# Keystone RV Company

## SAFETY ADVISORY # 22-434

### Lippert Awnings

# AWNING INSPECTION AND WELD/SEAM REPAIR

**Fig. 1**

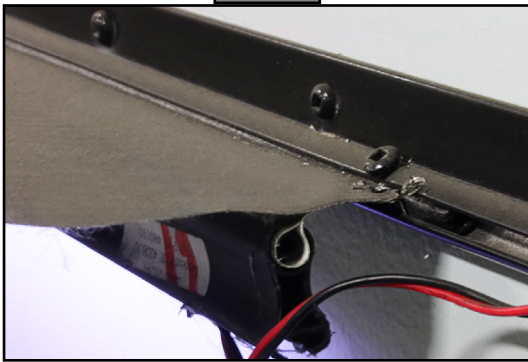
The purpose of this document is to provide guidance, as well as visual aides, to dealers performing inspection on units that may have insufficient awning weld(s). The inspection point is at the awning fabric seam at the awning rail at the wall of the unit (Fig. 1). This only affects awnings manufactured January 17, 2022 – June 14, 2022. The date of manufacture can be located on the variant code label (Fig. 2) located on the awning.

**Fig. 3**

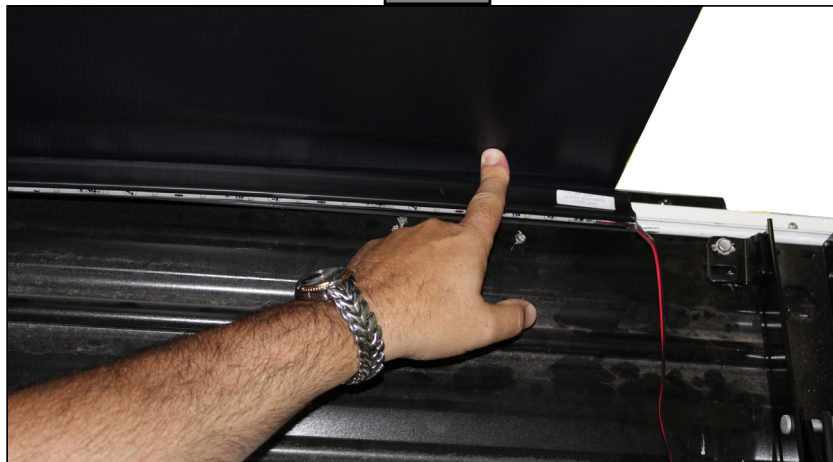
1. Extend the awning.
2. From underneath the awning, about 1" to 1.5" from the fabric edge, push up on the fabric with one finger (Fig. 3) until the awning fabric is flush with the top of the awning rail. Look for any separation or visible daylight at the seam. Perform push test at both ends of the awning.

**Fig. 4**

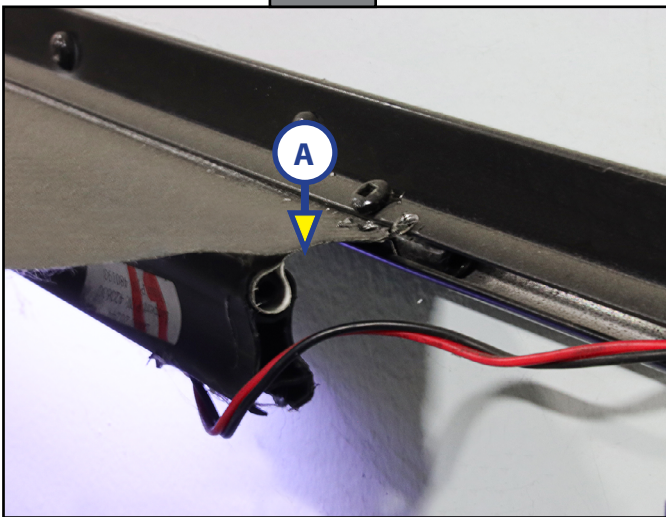
1. Position stepladder next to the unit to view the topside of the awning at the unit wall from either end (drive/idler side).
2. Inspect the weld near the awning rail (Fig. 4A).
  - A. Fig. 4 shows no separation at the seam. It does not require repair or replacement.
  - B. Fig. 5 shows separation at the seam (Fig. 5A).
    - I. If the separation is less than 6 inches, repair can be accomplished using the procedure described in [TI-434](#).
    - II. If the separation is over 6 inches it will require awning fabric replacement using the procedure described in [TI-166](#).
